Review of May 2020 Catastrophic Tank Failure, HPP-3, Norilsk

Independent Environmental Advisory
Support to the Nor Nickel Environmental Task
Team
(ETT)

25 November 2020

Photographs: Tank No.5 Failure

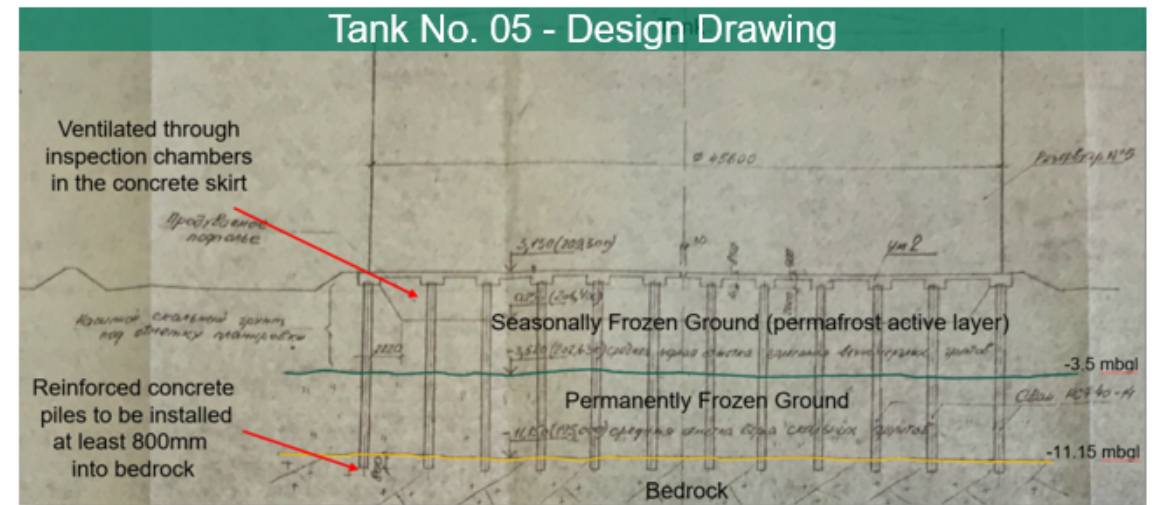
Failure of some of the reinforced concrete piles which supported the tank

Interior of the tank showing a large depression caused by pile failure which in turn caused failure of the common plates dragging the annulars inwards resulting in failure where the plates met the shell

Rupture of the tank shell where the wall is welded to the floor

Summary Root Cause Analysis: Tank No.5 Failure

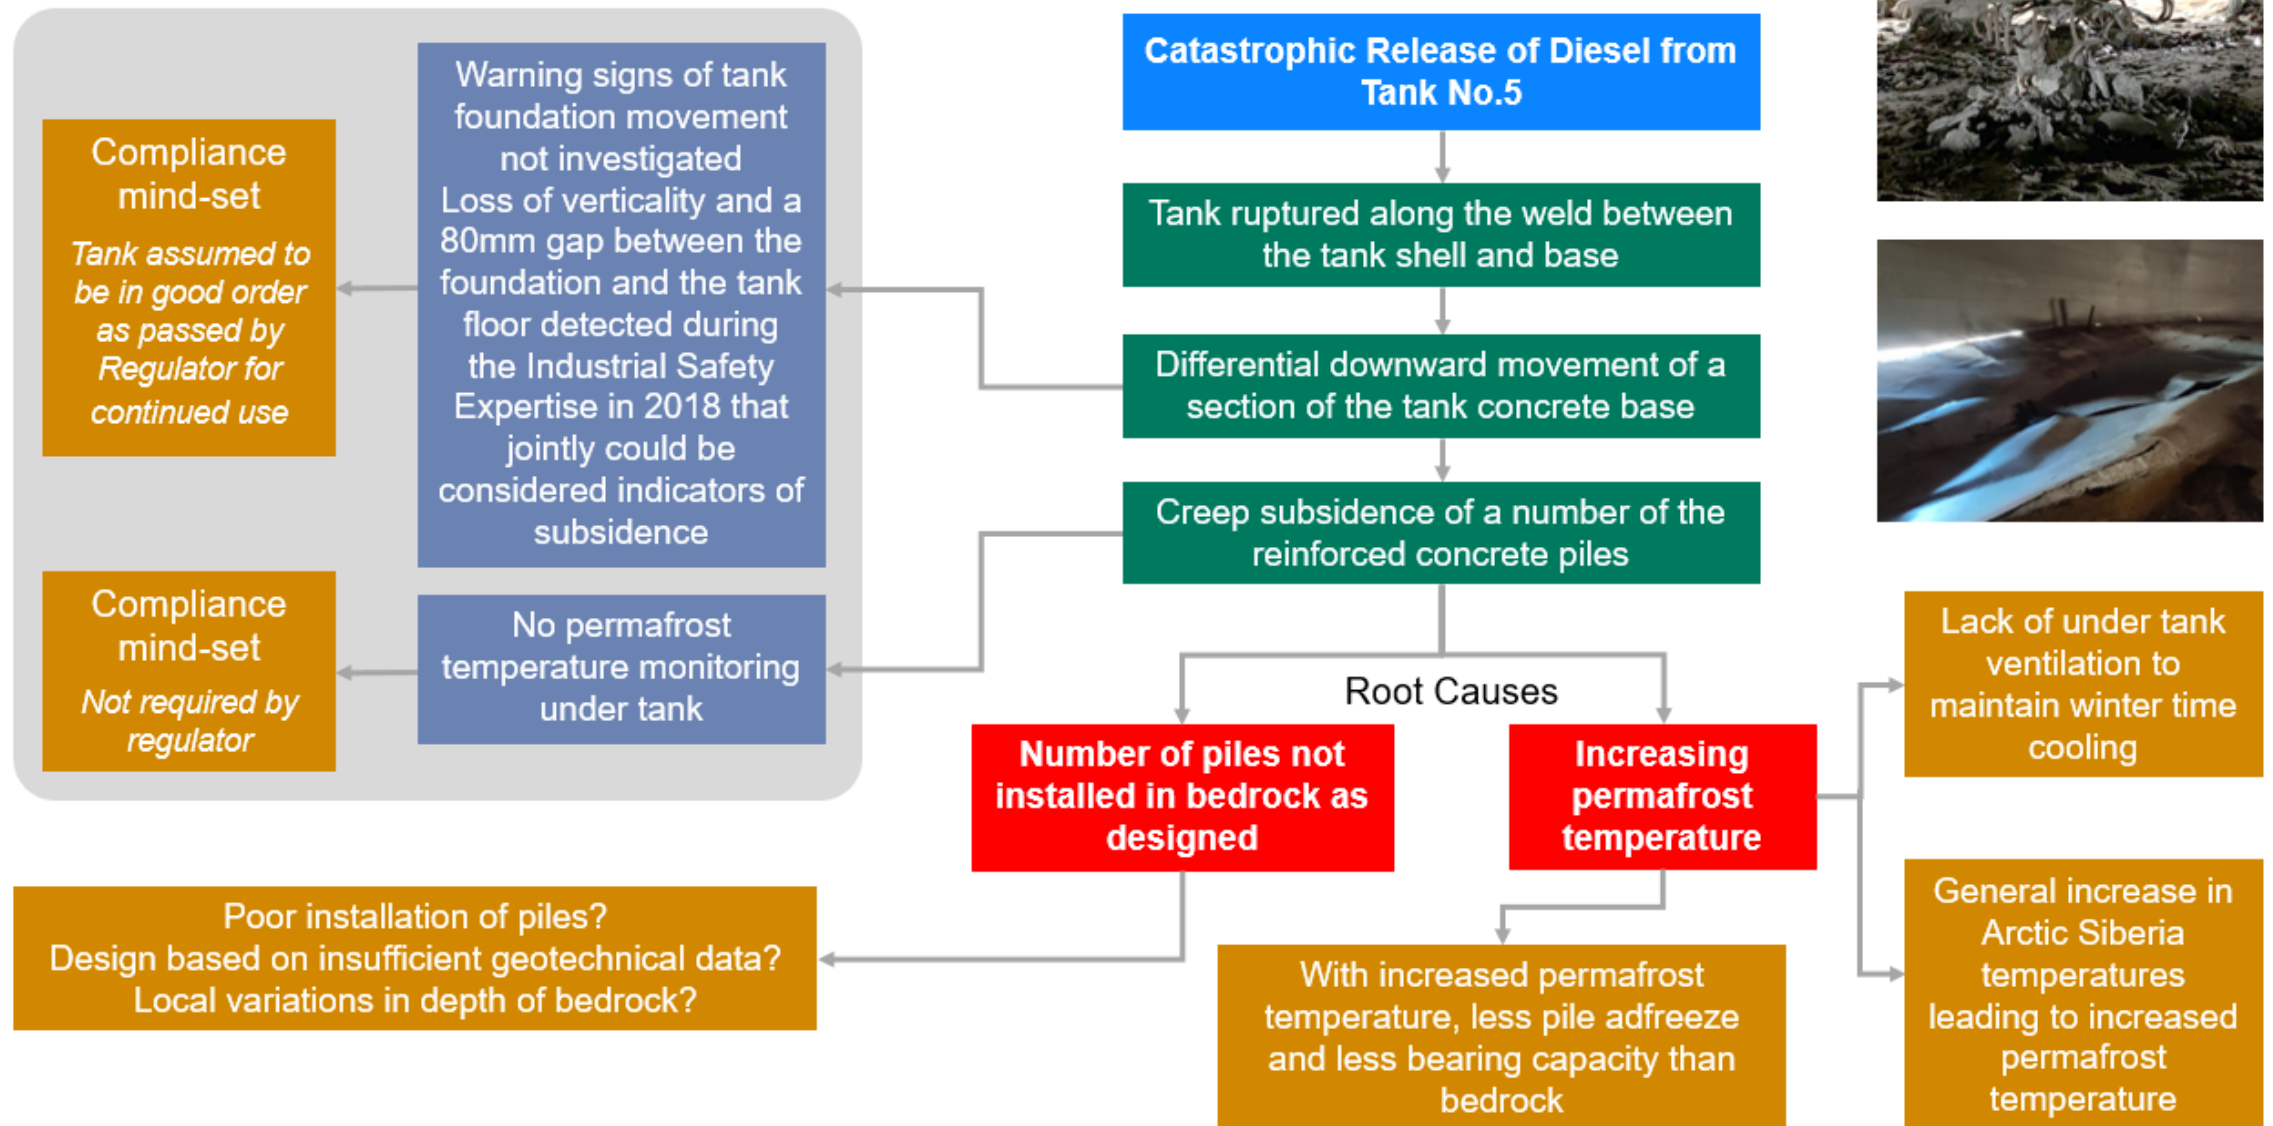
- The likely cause of the tank failure was differential subsidence of the tank base foundation. This would appear to have been a result of the failure of some of the reinforced concrete piles which supported the tank.

- This subsidence resulted in a rupture of the tank shell where the wall is welded to the base.
- Preliminary results of the regulator incident investigation reported that several of the piles were found to be shorter than the design length and not installed 800mm into the bedrock. This would mean that these piles were supported by the permafrost soil layer rather than the bedrock.

- This suggests that increasing permafrost temperature, linked to reduced adfreeze and bearing capacity of soils and resultant creep settlement of the piles not installed into bedrock was the likely failure mechanism.

- Loss of verticality and 80mm gap between the foundation and the tank floor detected during the Industrial Safety Expertise in 2018 that jointly could be considered indicators of subsidence

- Lack of focus on the foundation during the tank inspection
 - Lack of permafrost monitoring (not required by the regulations due to the tank design)
- However underpinning all of this is the fact that if all piles had been installed as designed into the bedrock, this failure would not have happened.

Summary Root Cause Analysis: Environmental Consequence

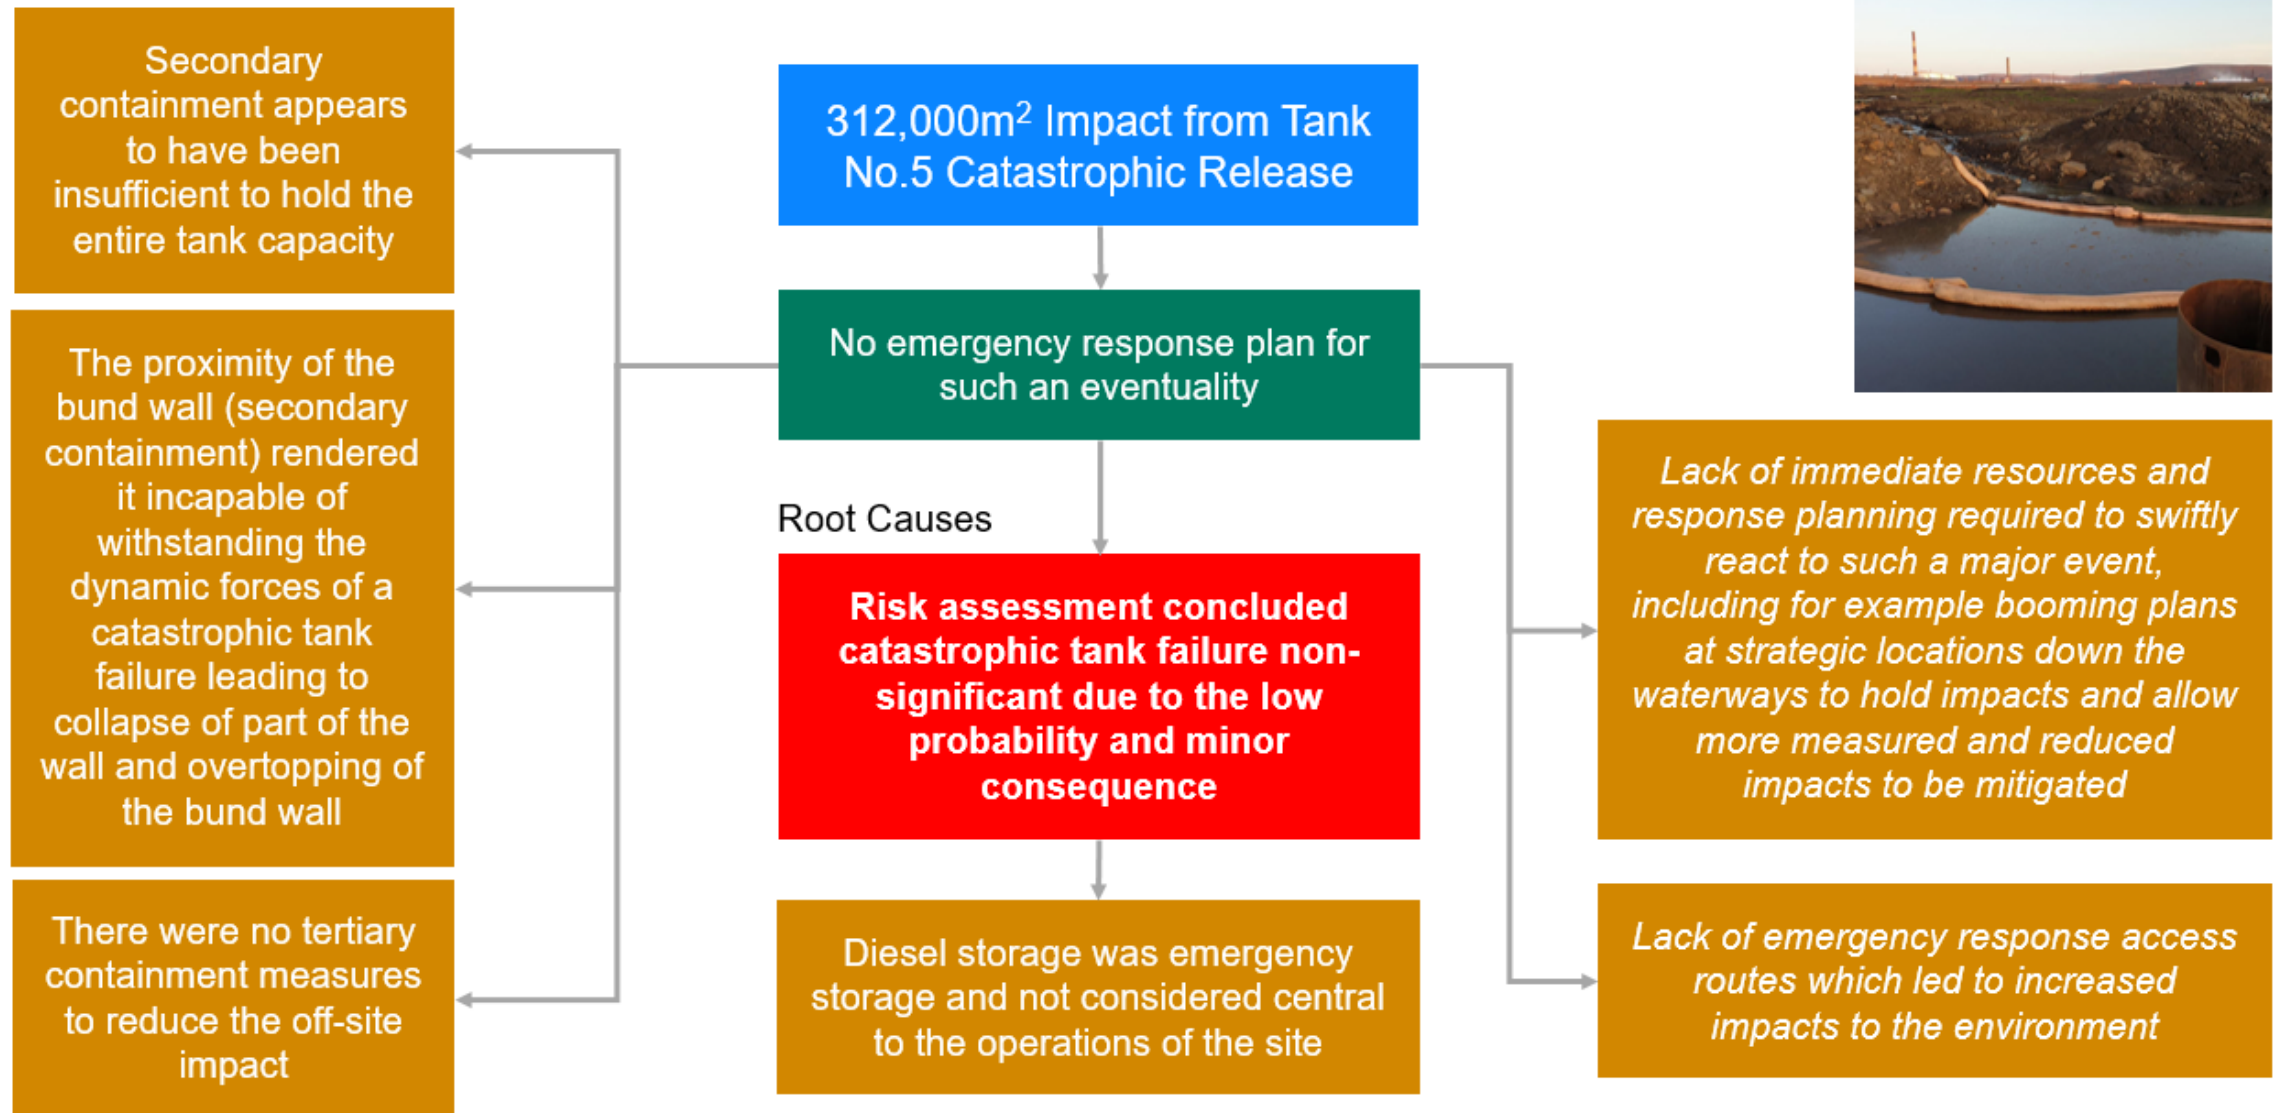
- The following key factors contributed to the catastrophic scale of the spill impact:
 - The bund was insufficient in size to accommodate the tank volume and the bund wall was not capable of preventing the dynamic forces of a catastrophic tank failure forcing diesel over the bund wall.

- Inadequate risk assessment in the Safety Declaration (SD). The catastrophic tank failure scenario was assessed as non-significant due to the low probability (1.5×10^{-5} per year) and minor consequence (limited impact on soils). The SD did not contain any recommendations to mitigate such scenario.

- Inadequate tertiary containment measures to reduce the off-site impact of a catastrophic tank failure.
 - Lack of immediate resources and response planning required to swiftly react to such a major event.

- No detailed spill modelling was undertaken to inform the Oil Spill Response Plan (OSRP). The OSRP estimated the impacted area even less comparing to the one calculated in the SD and therefore mitigation activities were limited to contaminated soil removal and pumping of diesel fuel from the tank bund.

- *Check the bund capacity/ design of all tanks as it may be necessary to construct a secondary bund around these tanks, reduce the height of the bund wall between tanks or increase the overall bund capacity*
- *Undertake modelling to determine where to locate tertiary containment systems, inform emergency response planning and located spill response equipment*
- *Look to the provision of emergency response access routes and booming locations*
- *Update the spill response plan and carry out emergency response exercises*

Recommendations: Primary Containment (Short & Medium Term)

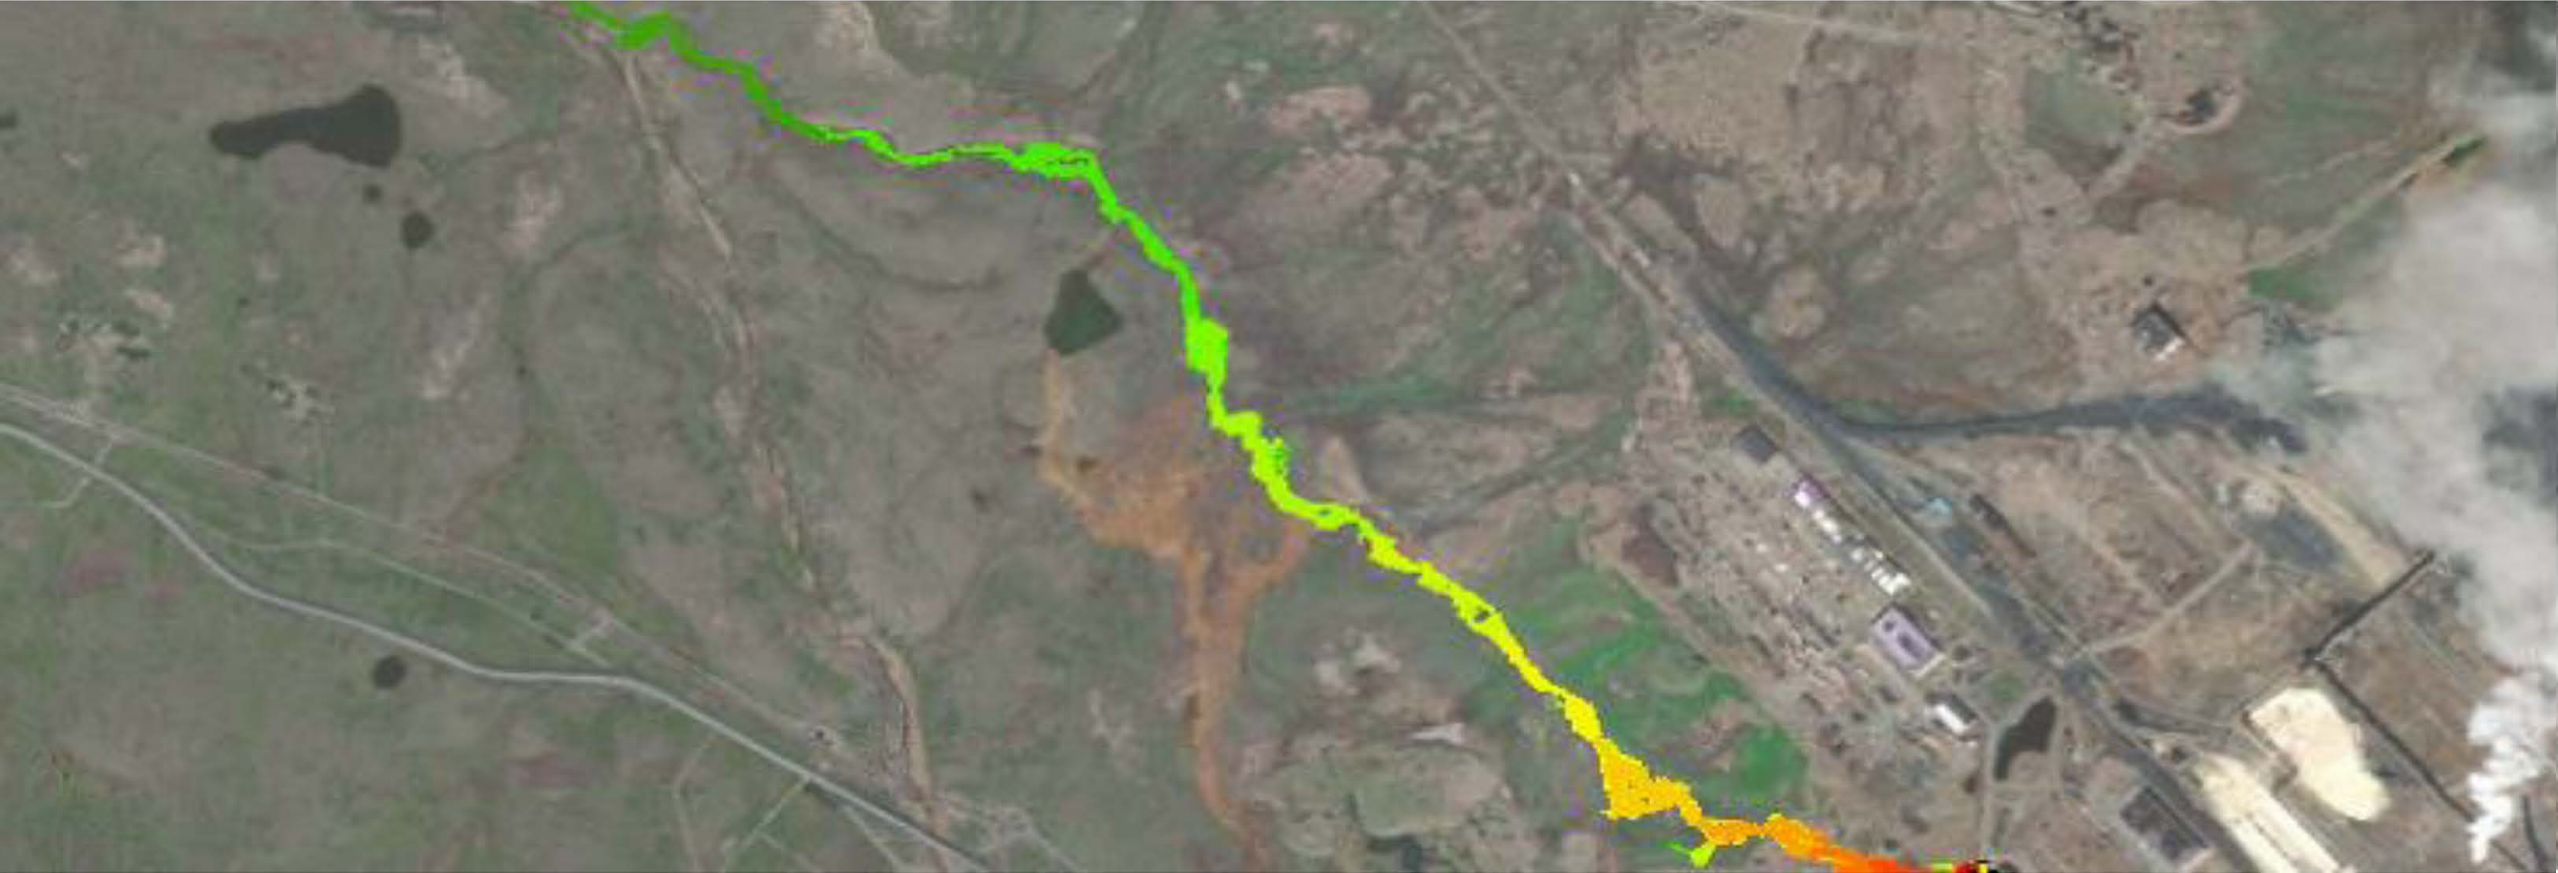
A robust risk-based Safety Management System would improve confidence in preventing catastrophic tank failures. Such a system would reduce the likelihood of the most hazardous scenario itself by investing in the most effective barriers and responding in case of emergency in a way to significantly reduce the scale of consequences and impact.

- *Inspect foundations of all tanks with the similar pile design as Tank No.5 to look for evidence of subsidence and confirm all piles installed as designed. Remove or reduce fuel level in “at risk” tanks*

- *Check to ensure they have adequate ventilation under the tank as per the design intentions in order to preserve the permafrost*
- *Extend assessment to all other tanks focused on review of tank foundation stability with respect to permafrost active zone and trend for climate warming reducing bearing capacities of soils – consider the need for any additional permafrost related protection measures, such as thermosyphons*

- *Design and instigate a permafrost monitoring system for all tankage*
- *Develop a management system to improve the integrity of the primary containment. We recommend strengthening the management systems supporting tank integrity, such as improved inspection and maintenance, anti-corrosion measures and possibly decommissioning tanks where it is considered there is a significant risk of catastrophic failure*
